PROPOSED SUBSURFACE WASTE DISPOSAL SYSTEM DETAIL SHEET

SUBDIVISION: BALLARD WOODS

LOT 165

JOSEPH ALEXANDER DRIVE
 CUMBERLAND HOMES, INC.
 THE CAPE
 LOT # 165 BALLARD WOODS
 SCALE: 1"=40'

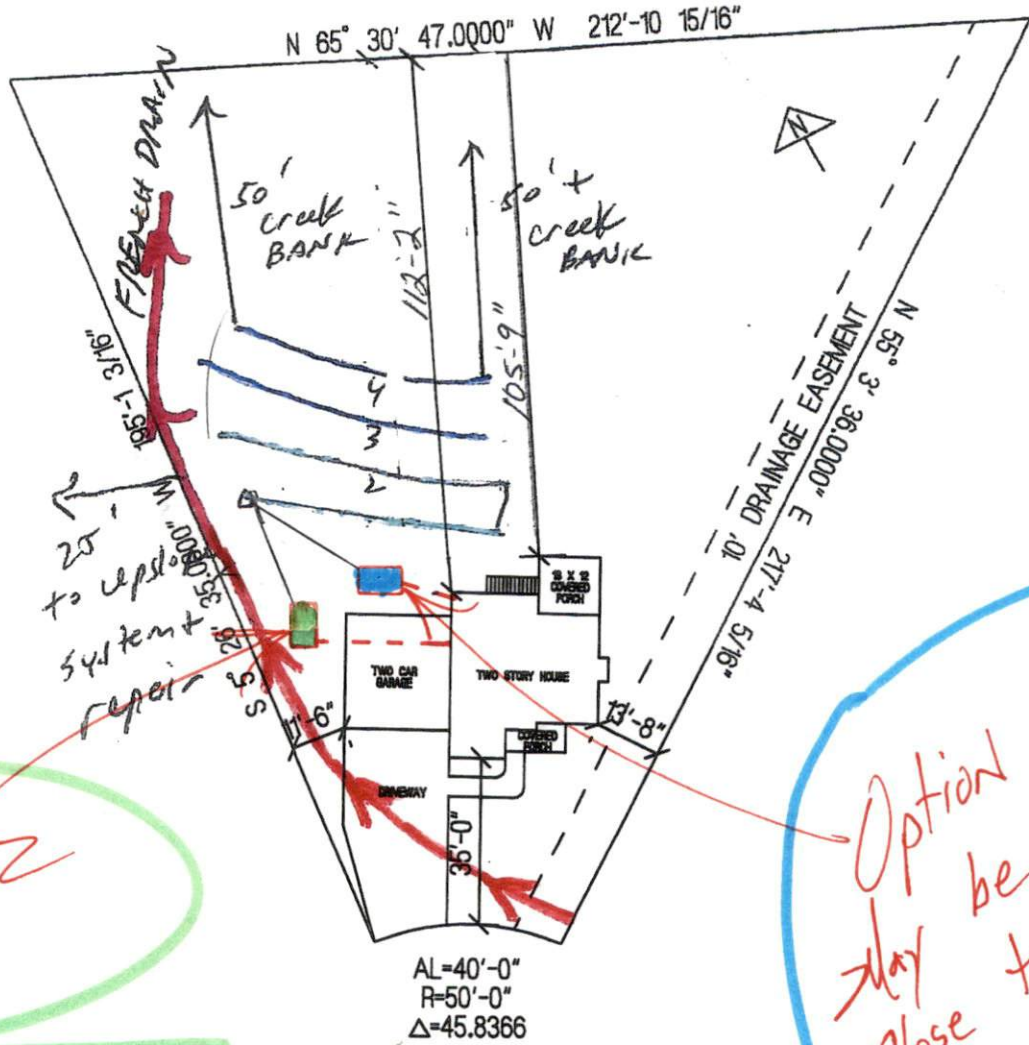
ADD FRENCH DRAIN AS SHOWN
DIRECT ALL GUTTER WATER AWAY
FROM SYSTEM/REPAIR

Tank Location ?

Option #2

Option #1
 may be too close to top line ?

Would require going through garage wall on both side which isn't an issue.
